ADDENDUM #3

February 16, 2011

Re: Harrisburg Area Community College
Public Safety Center – Law Enforcement Complex & Site Improvements
Solicitation # 11-13

From: Eastern PCM, LLC
Construction Manager – HACC
645 N. 12th Street, Suite 200
Lemoyne, PA 17043

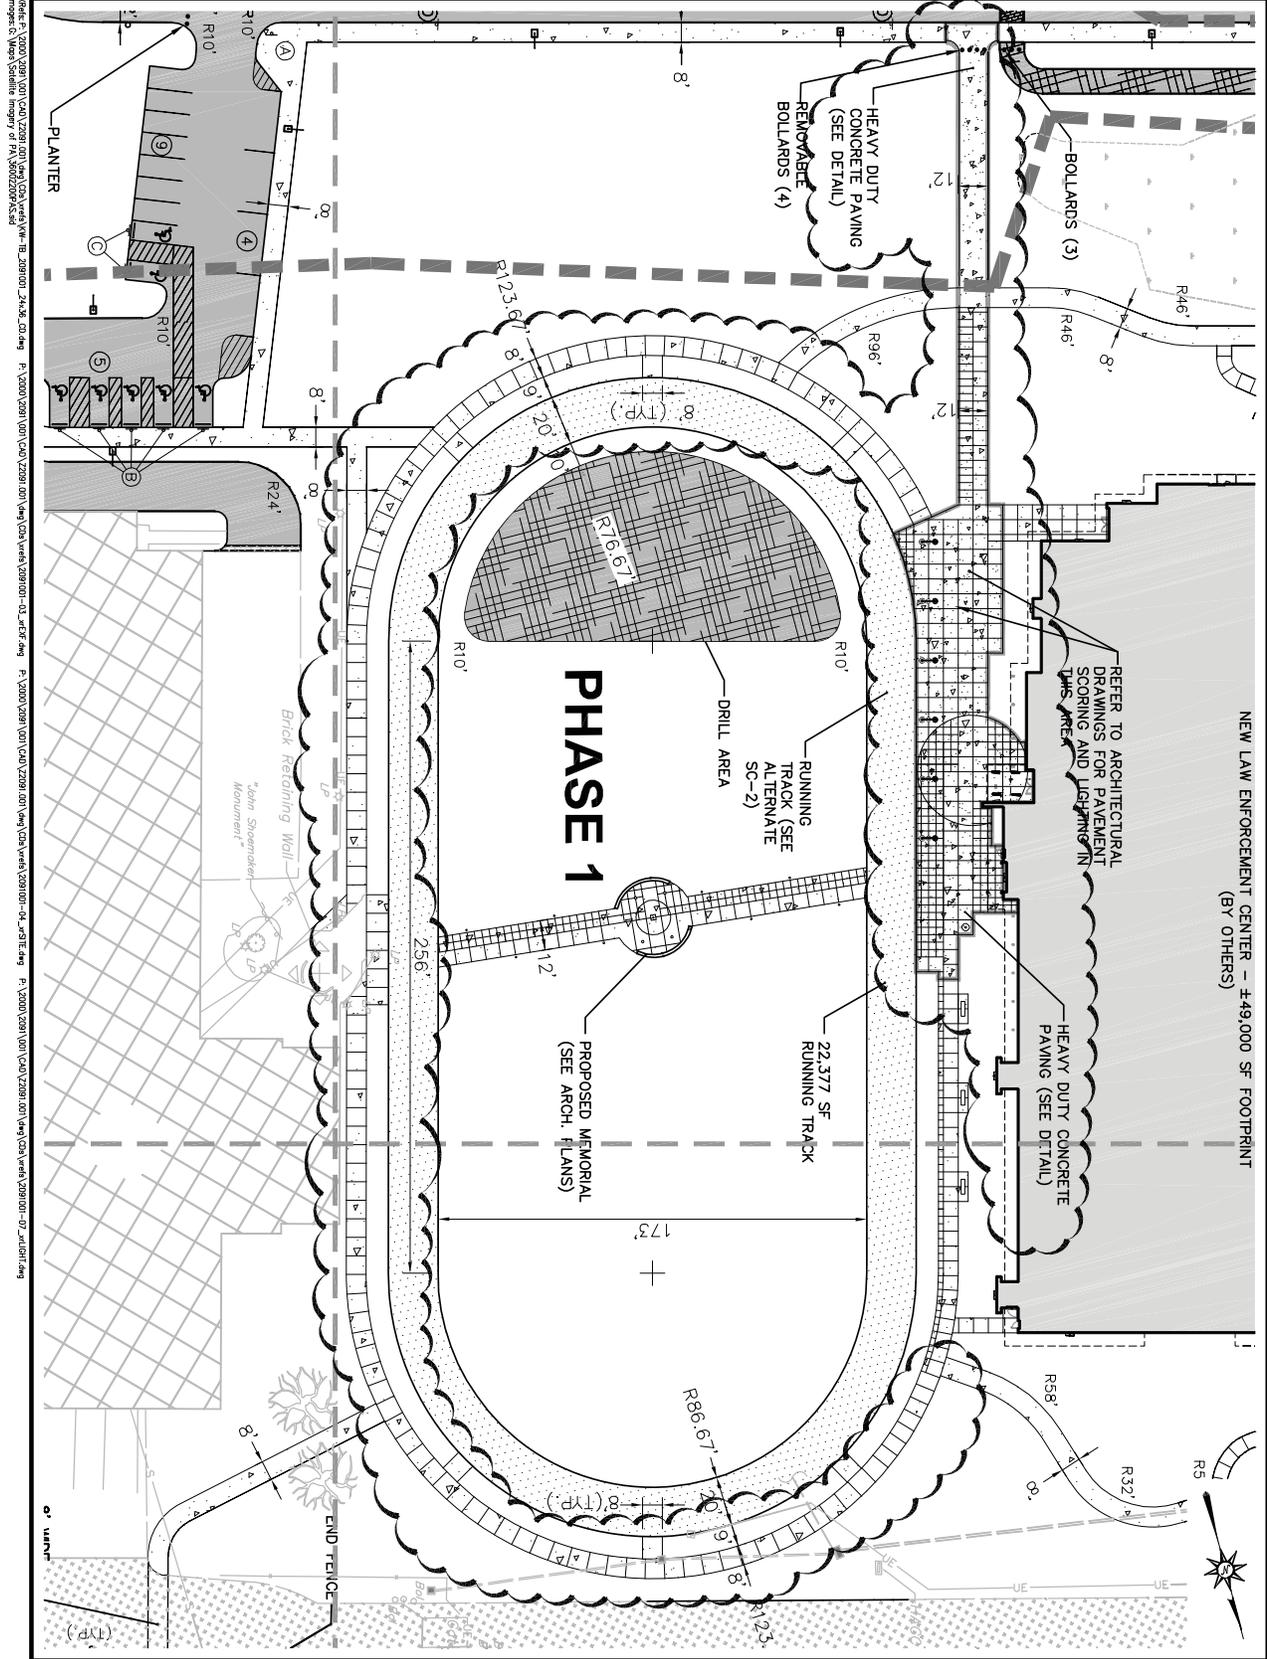
- E. Drawing C8: REVISE concrete scoring pattern around running track. Clarification on limits of heavy duty concrete provided. Refer to sketch SC-4 included in this Addendum #3.

ADDENDUM NOTES:
 1. LIMITS OF HEAVY DUTY CONCRETE IN FRONT OF BUILDING.
 2. CONCRETE SCORING PATTERN AROUND TRACK EXTENDED

ADDENDUM NO.: 3 REFER TO PLAN SHEET NO.: 31

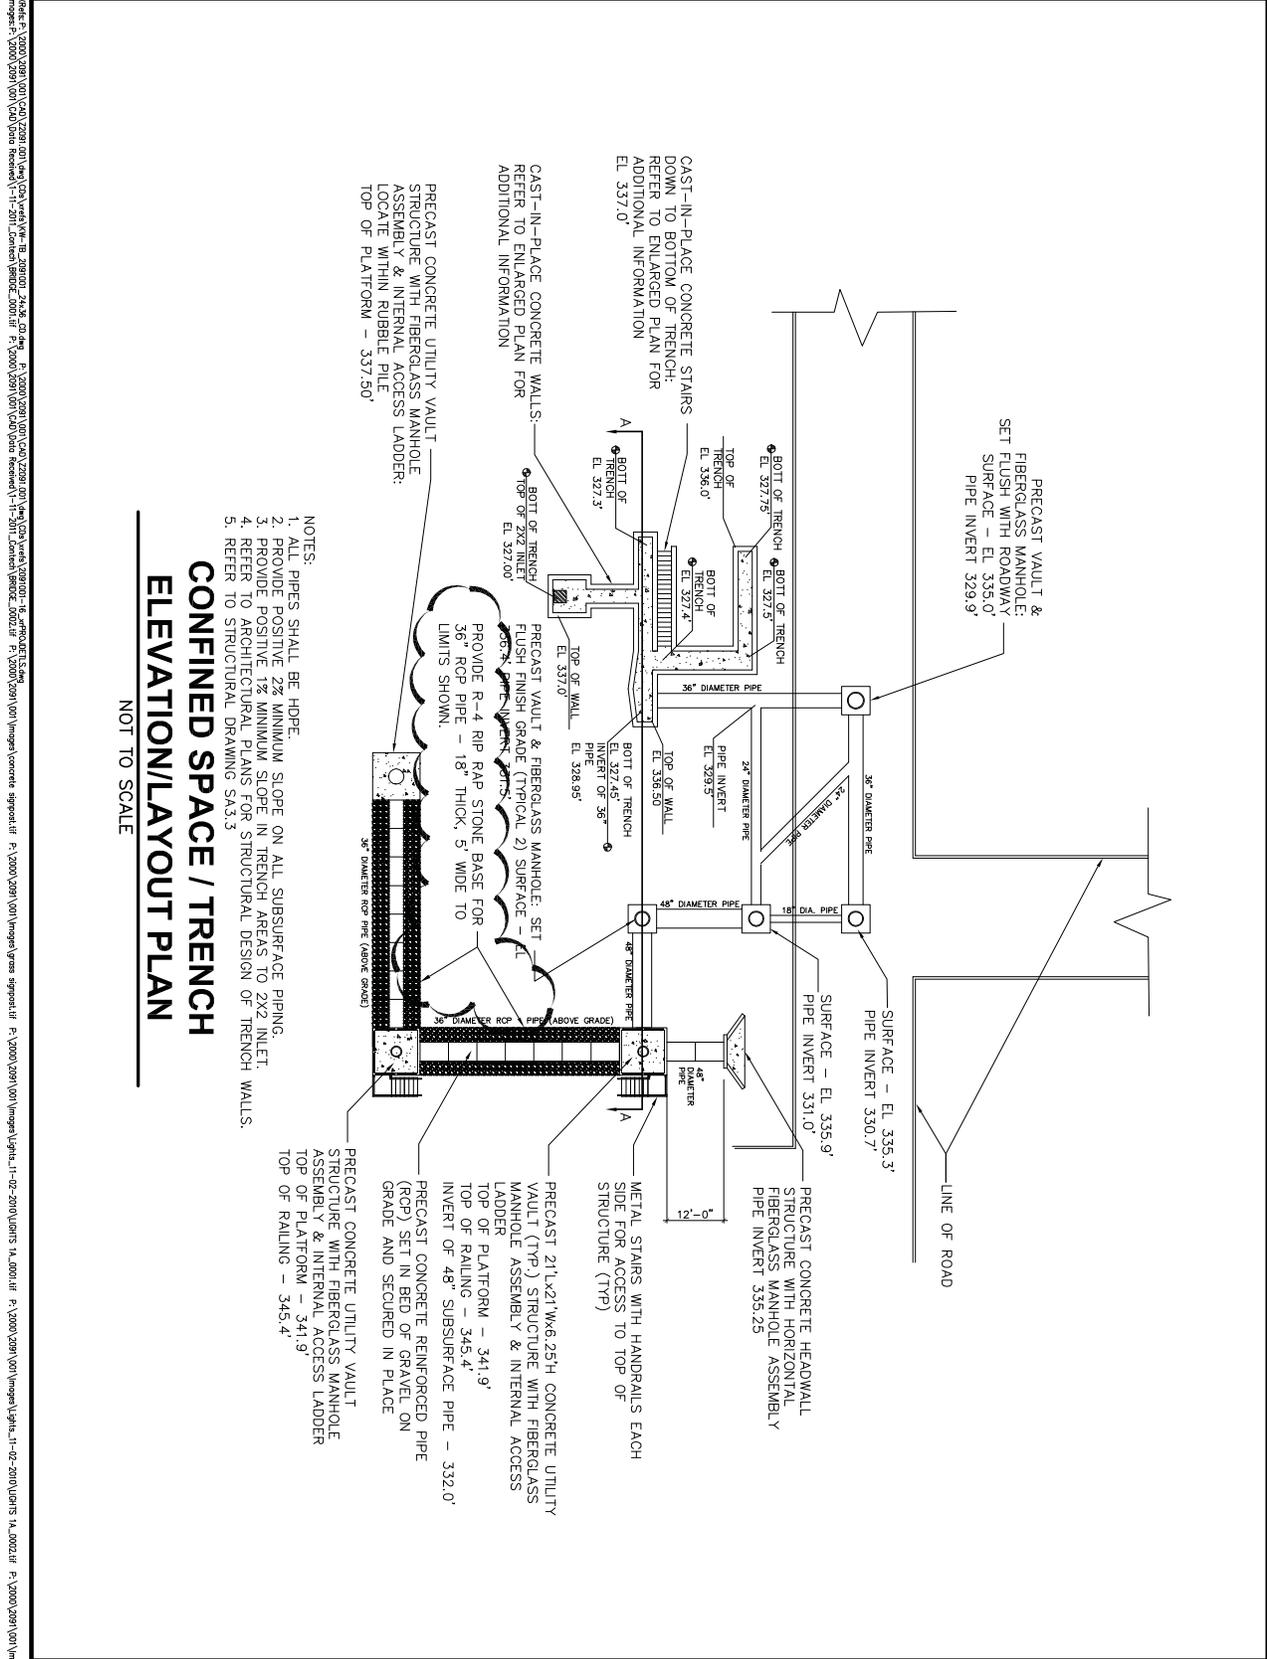
- H. Drawing C31: ADD Riprap at confined space/trench prop area. Refer to sketch SC-7 included in this Addendum #3.
- I. Drawing C8 (E&S Plans Phase 1):

ADDENDUM NOTES:
 1. ADDED R-4 RIP RAP BASE

PANEL DESIGNATION: EA LOCATION: A117
 PANEL TYPE: TVSS: N/A
 SERVICE: 480Y/277 VOLTS 3 PHASE 4 WIRE
 MAIN BUS: 100 AMPS MAIN RATING: 30 AMPS
 MOUNTING: SURFACE MIN. K.A.I.C.: 14

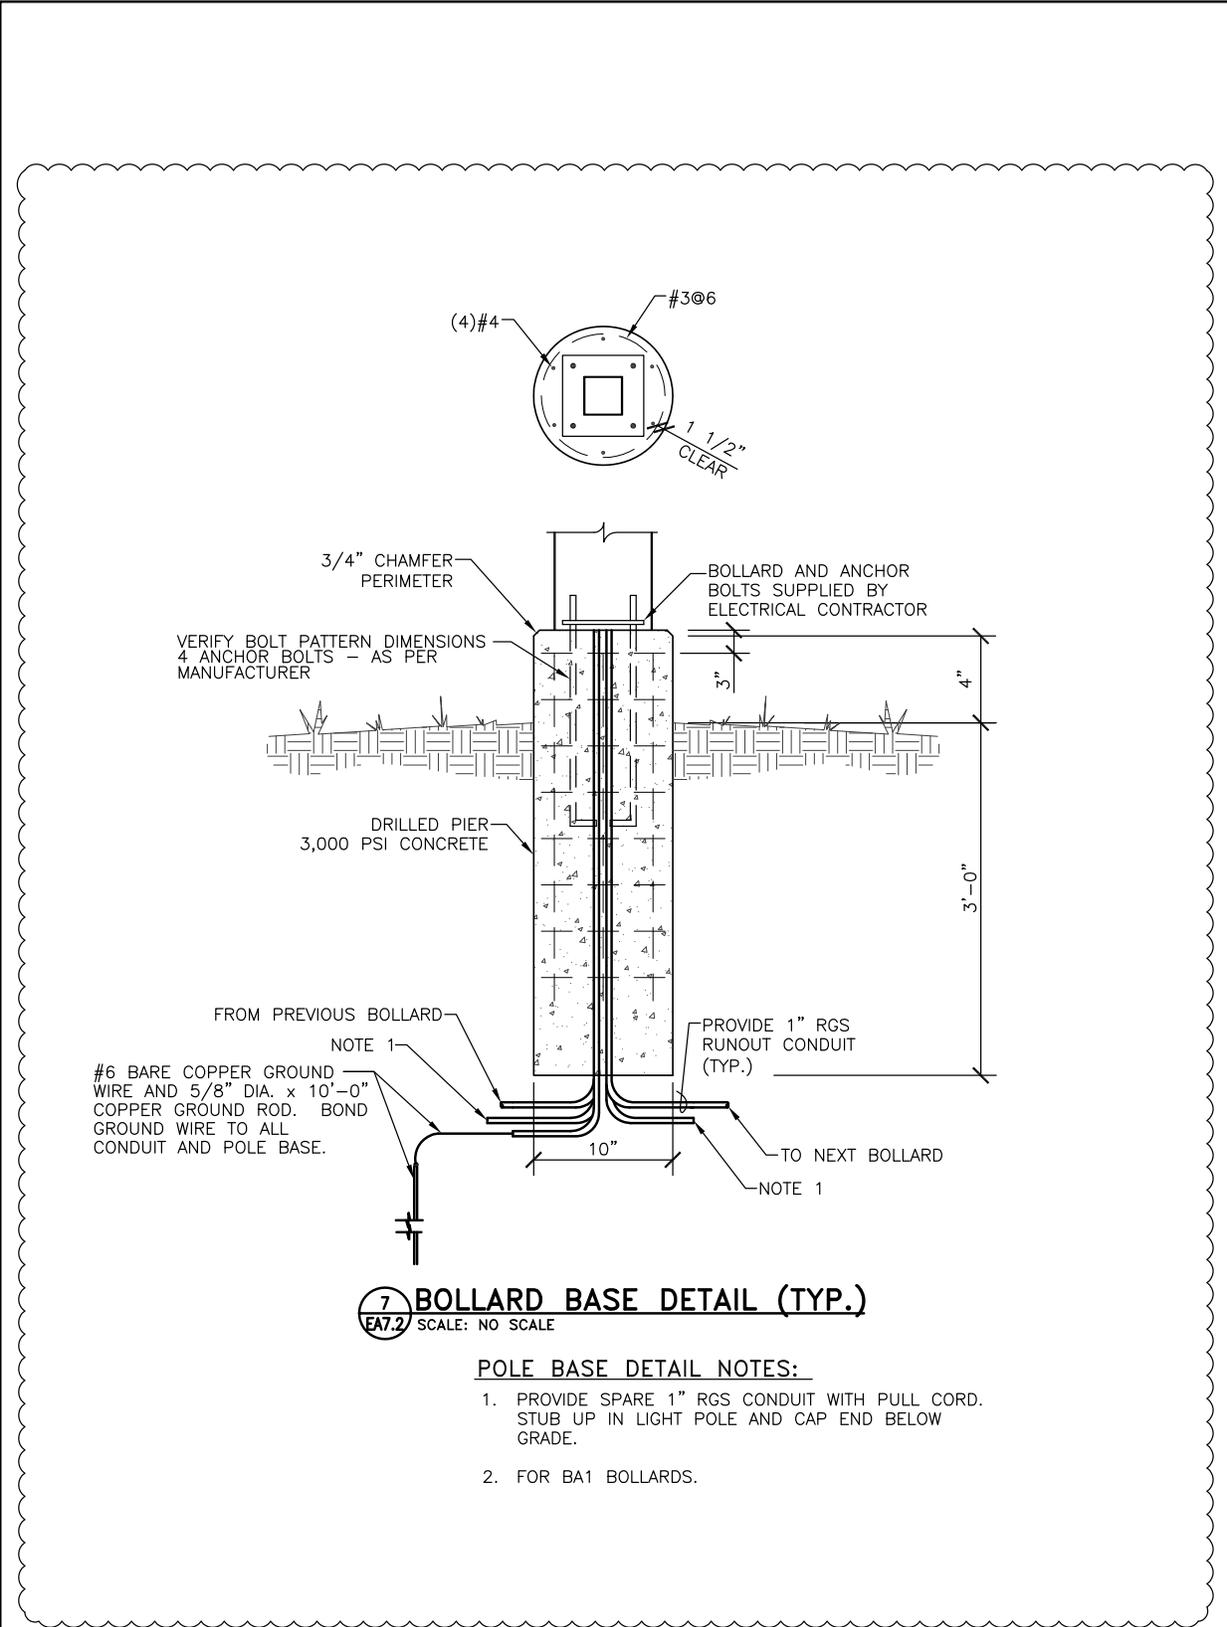
- P. Drawing EA6.2: ADD sketch SK-EA6.2-1, Panel Schedule EA included in this Addendum #3.
- Q. Drawing EA7.2:
 - a. DELETE the reference to bollard on all other base details. Refer to sketch SK-EA7.2-2 for bollard base included in this Addendum #3.

7 BOLLARD BASE DETAIL (TYP.)
 EA7.2 SCALE: NO SCALE

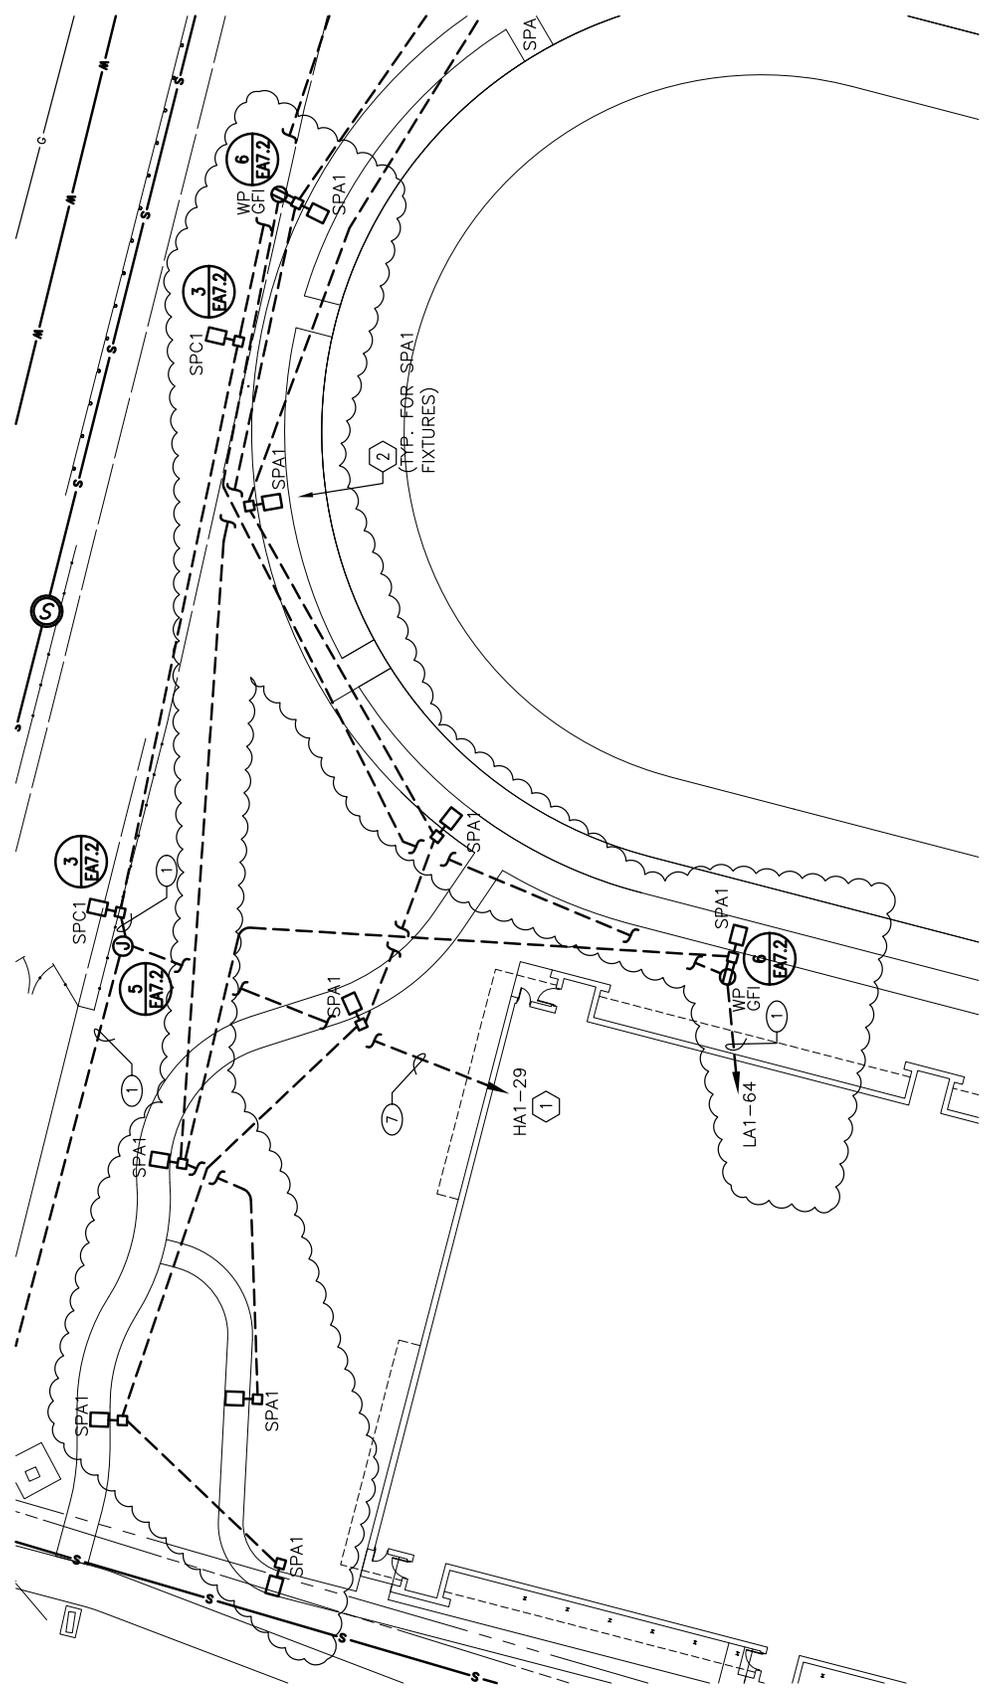
- H. **Q:** The detail shows a base for a bollard fixture that is 66" below finished grade. The bollard itself is only 43" high. Is the depth of this base necessary/required?

- A:** This is the car extrication bollard detail on sheet 29. The depth is necessary since cars will be placed against the bollard for training purposes

PARTIAL SITE PLAN - BUILDING - LIGHTING
 SCALE: 1"=30'-0"

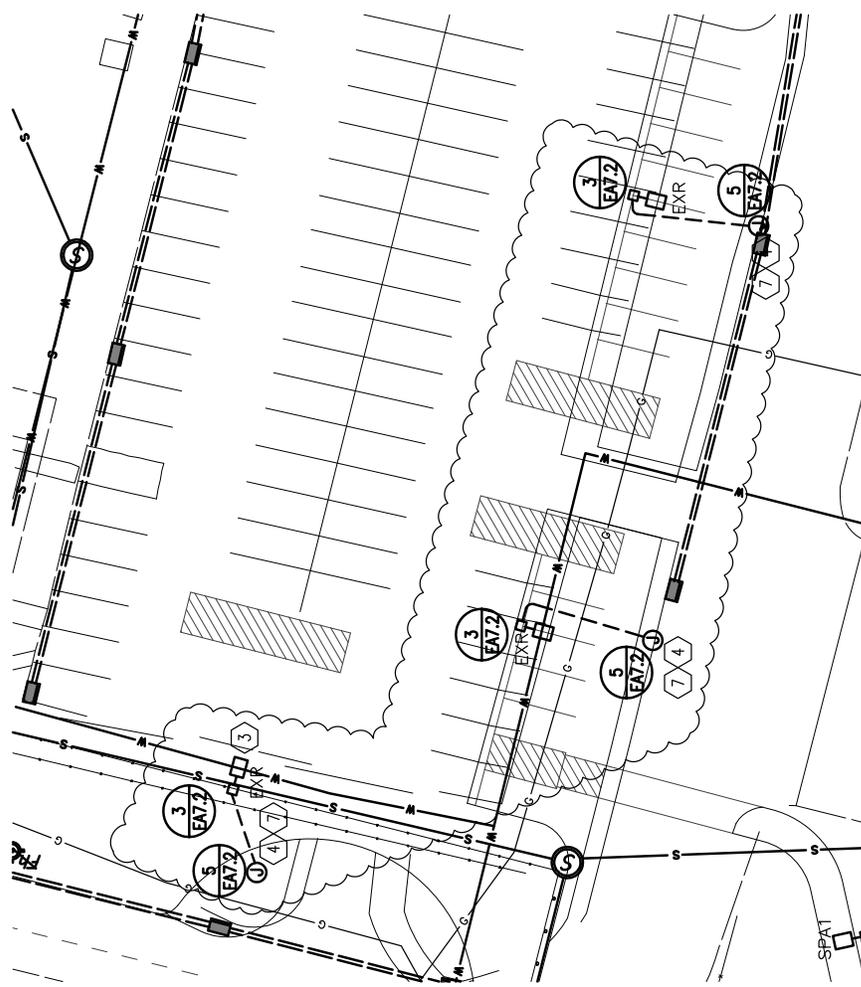
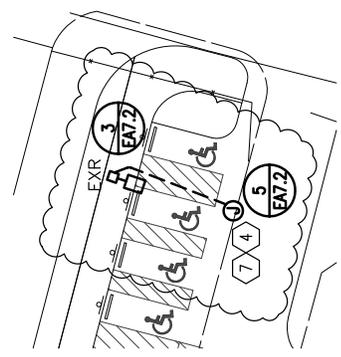
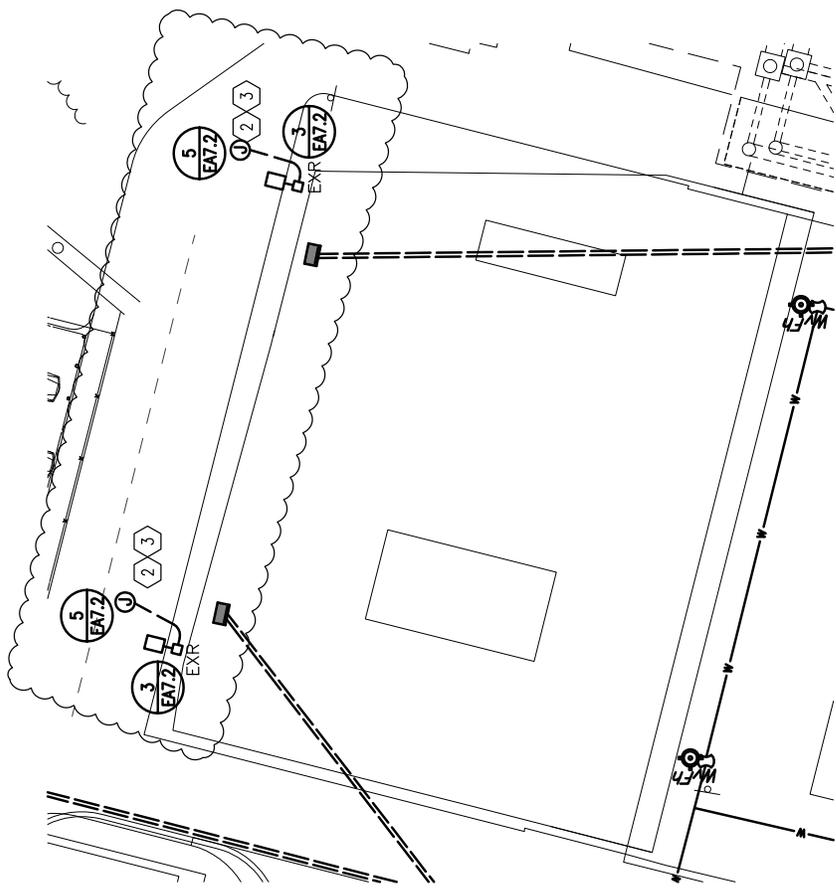
- b. REVISE pole base diameter to read 12" on Detail 1 and 6.
- R. Drawing EA7.3:
 - a. ADD sketch SK-EA7.3-3 included in this Addendum #3.
 - b. ADD sketch SK-EA7.3-4 included in this Addendum #3.

- S. Drawing EA7.4: ADD sketch SK-EA7.4-2 included in this Addendum #3.
